SOUTHERN SANDOVAL COUNTY FLOOD CONTROL AUTHORITY

IFB# 2017-02 – ACAPULCO ROAD IMPROVEMENTS, PHASE 1

ADDENDUM #1

March 22, 2017

PLAN AND PROFILE II

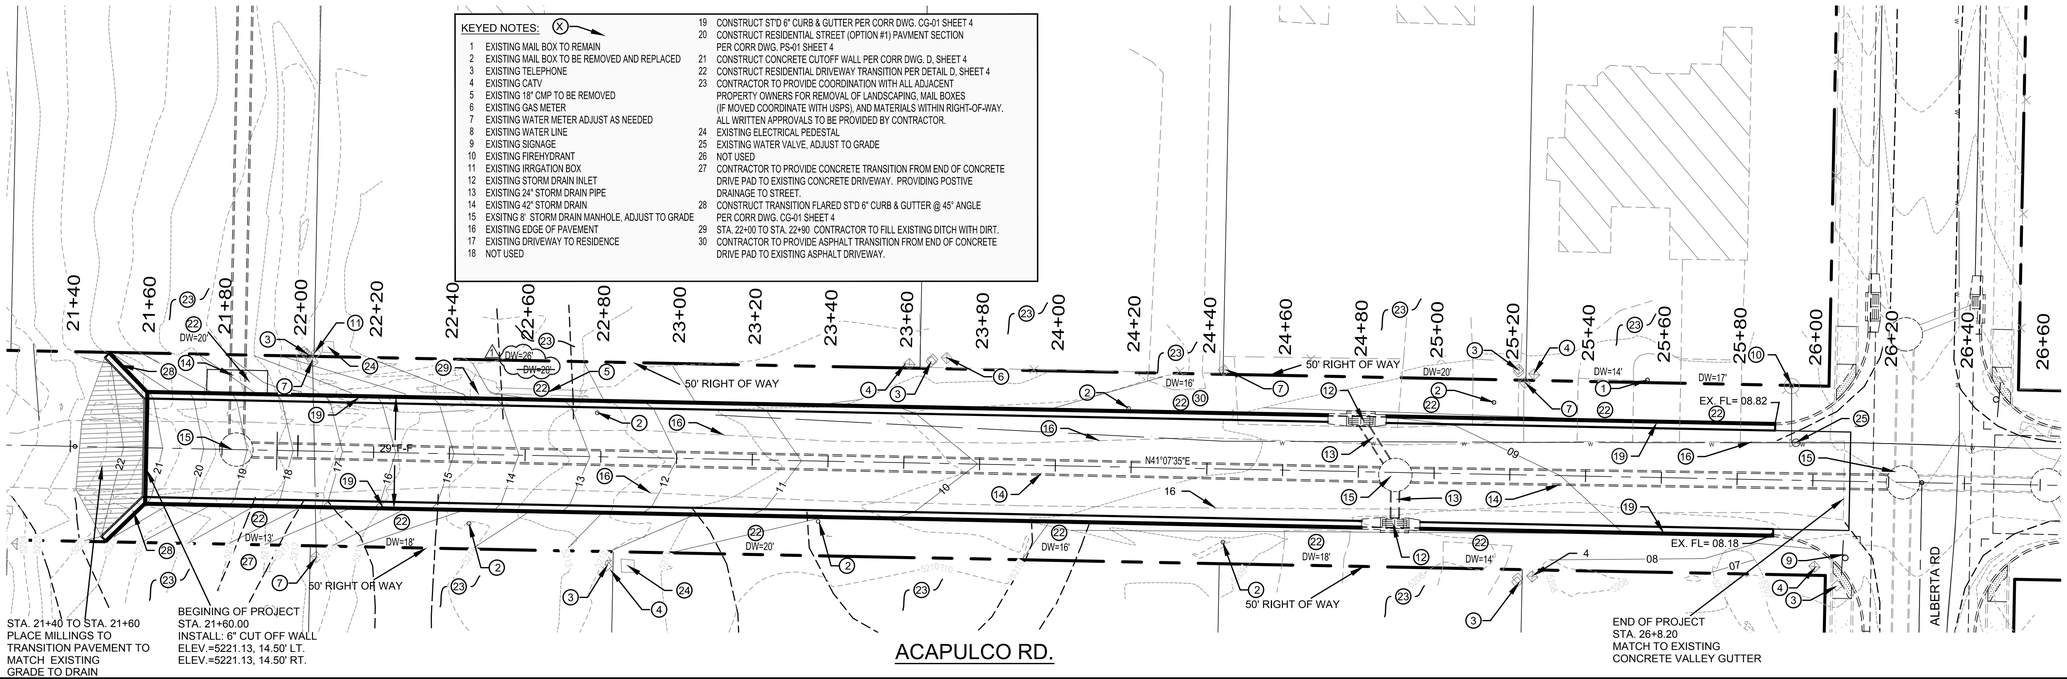
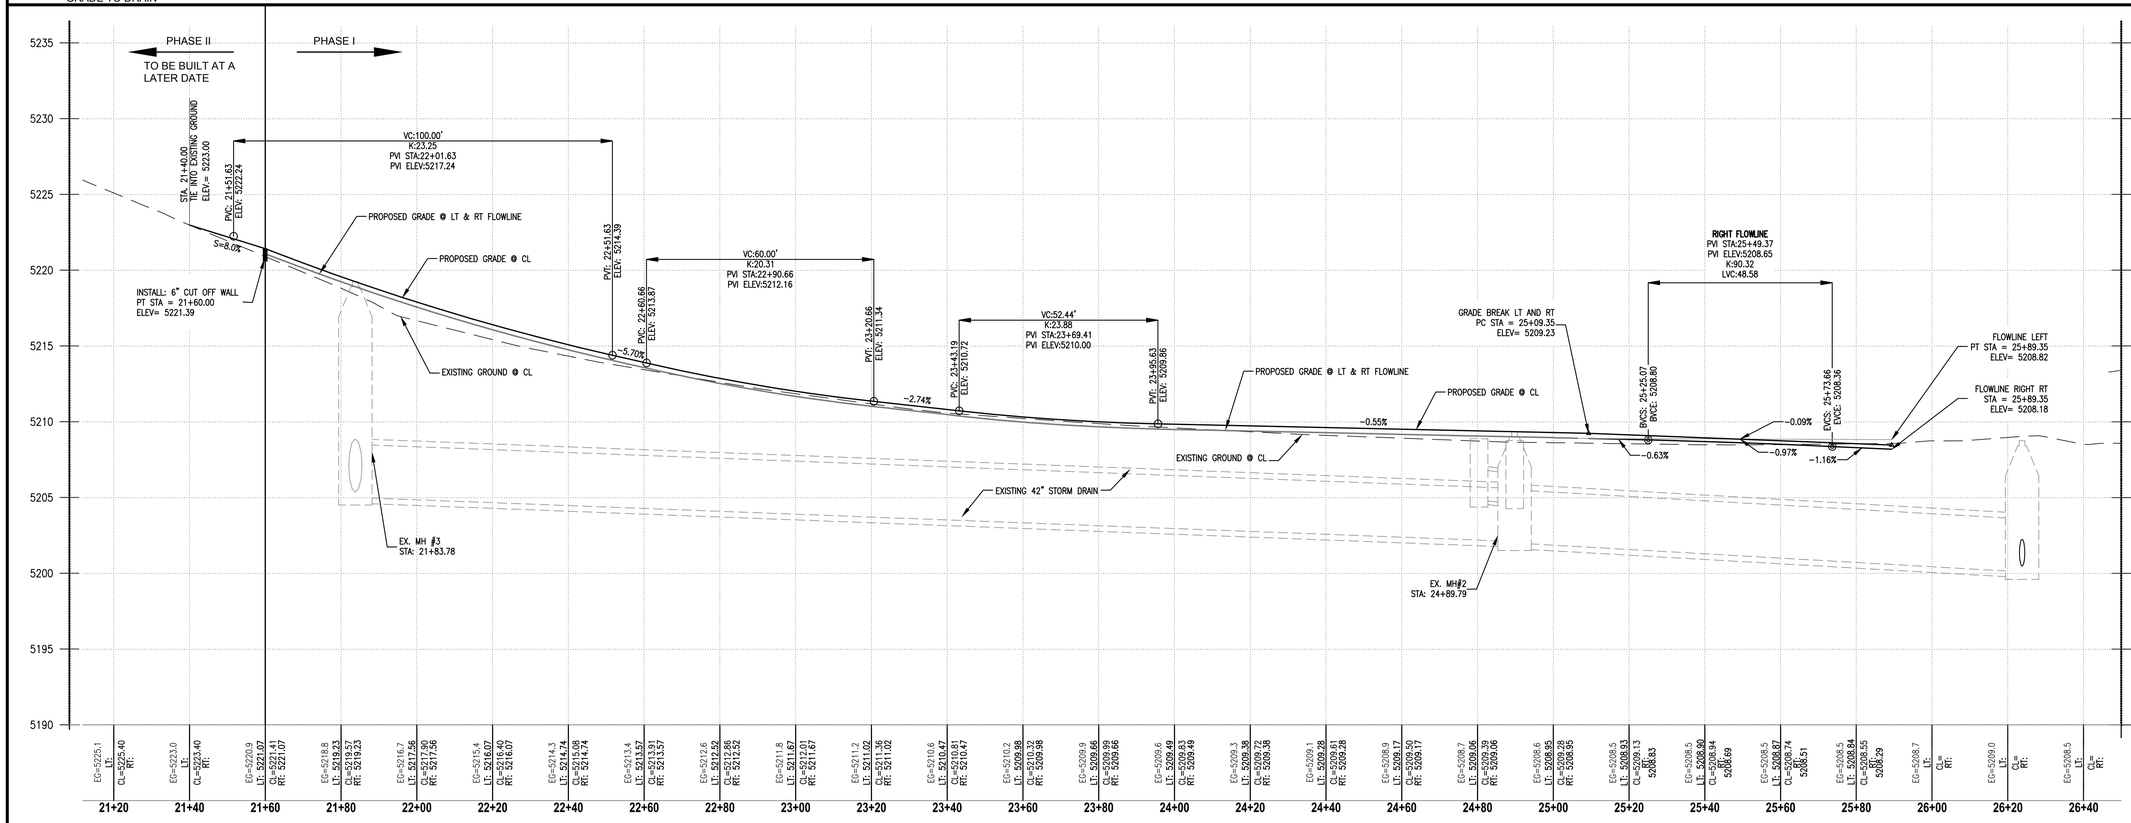
Q11: Please clarify the dimensions for Note 22, sheet 3 of 6, Drive-pads. Is there a new concrete drive-pad from curb and gutter to the R-O-W line or is the depth shorter by a certain length, short of the R-O-W mark?

- Replace cover sheet with the attached signed version.
- Replace sheet 3 of 6 with the attached revised sheet 3 of 6.

NO.	REVISION	BY	DATE
1	DRIVEWAY WIDTH	DBT	3/20/17

A11: As shown on the driveway detail on sheet 4 of 6, the concrete driveway stops 3 feet from the back of curb.
